VERIFICATION / CERTIFICATION REPORT

LAGES METHANE AVOIDANCE PROJECT IN BRAZIL

(UNFCCC Registration Ref. No. 0268)

REPORT No. 2011-1562

Figure 1: Variation to the electricity price in spot market from 1 June 2009 to 31 May 2011 /33/:

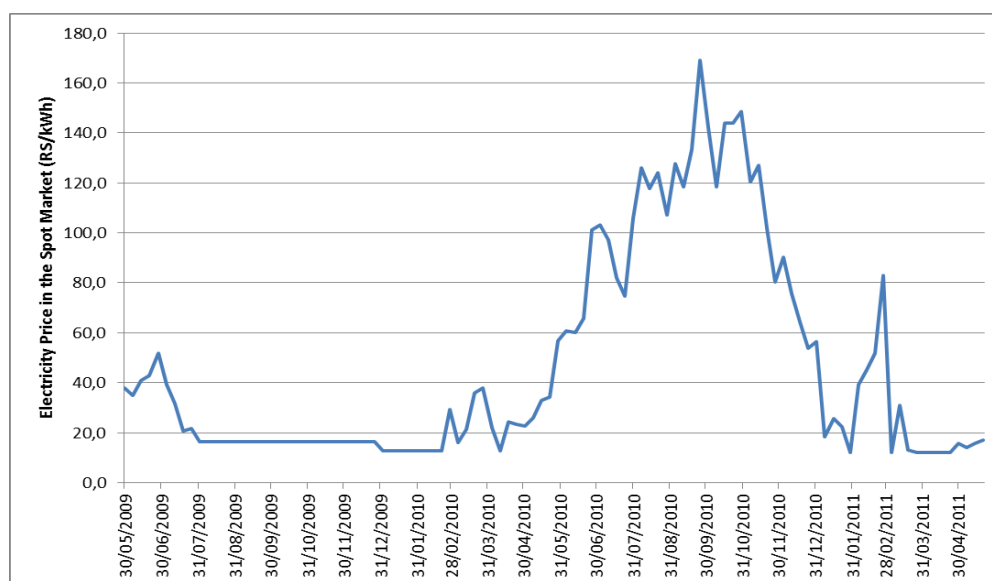
CL ID	Corrective action request	Response by Project Participants	DNV's assessment of response by Project Participants
CL 2	The monitoring report does not clear demonstrated in section E.6 the reasons for the higher consumption of wood waste and consequently higher plant load factor and electricity generation during a few months of the period under verification, specially the second semester of 2010.	The higher load factor was consequence of a drier season on the second semester of 2010, demanding additional thermal generation, besides the hydroelectric power generation, to supply the required power from Brazilian grid. The monitoring report was revised including this consideration.	<p>DNV has assessed the monitoring report version 3 of 22 March 2012 /1/, and the higher wood waste amount than that estimated in the revised PDD was caused by a dry season especially in the second semester of 2010, demanding additional thermal generation besides the hydroelectric power generation to supply the required power from Brazilian grid (which increases the general spot market price, since thermal energy is more expensive /33/).</p> <p>DNV is able to confirm the correlation of the over generation of emission reduction by the project activity during the period from 1 June 2009 to 31 May 2011 with the electricity price in the spot market and considers that this was a particular and isolated cause hence not demanding a revision of the project design to address the over generation of CERs.</p> <p>Therefore this CL is closed.</p>

Therefore, the higher consumption of wood waste was caused by the demand of the national grid for thermal electric energy during the dry season (second semester of 2010). Since the project participant had the technical ability (amount of wood waste and installed capacity) to supply such demand, the energy was then generated.
